## Product Change Notice (PCN)

PCN Number: **PCN-0451210R-01**

Product(s) Affected: **PJ-059A**

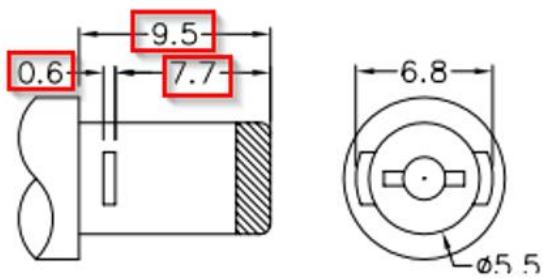
Description of Change: **Minor Housing and footprint differences. Material Change on the housing and terminals. See image Below**

PREVIOUS CUI DEVICES DETAIL / IMAGE			NEW CUI DEVICES DETAIL / IMAGE		
	MATERIAL	PLATING	DESCRIPTION	MATERIAL	PLATING/COLOR
center pin	copper	nickel	center pin	brass	nickel
terminal 1	brass	tin	terminal 1	brass t=0.30	tin
terminal 2	copper alloy	tin	terminal 2	bronze t=0.25	tin
terminal 3	brass	tin	terminal 3	brass t=0.30	tin
plastic	PBT		cover	PBT (UL94V-0)	black
			housing	PBT (UL94V-0)	black

MATING PLUG  
Jack Insertion Depth: 9.8 mm

MATING PLUG  
Jack Insertion Depth: 9.5 mm
